PRODUCT UPDATE

Number: #139
By: Applications Engineering Dept.
Date: June 9, 2014

1S Split Mid-Piece Length Modification

Details of change (continued)

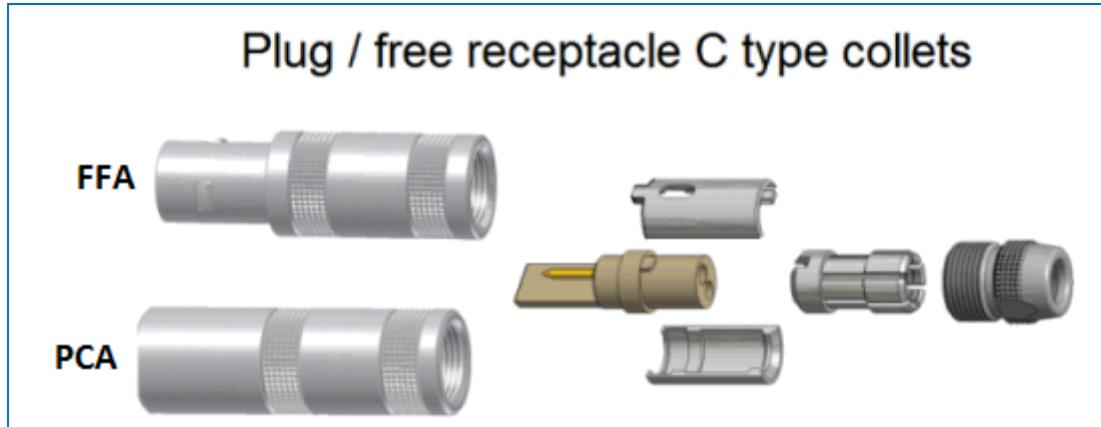
- 1) The 1S split mid-pieces will be 1mm longer and will have a "T" at the end of the part number (FGG.1S.155.LNNT).

- 2) The new new split mid-pieces will allow the use of the New 1S keyed inserts (Ref: Product Update #114) to fit both FFA free plugs and PCA free receptacles with C type collets:
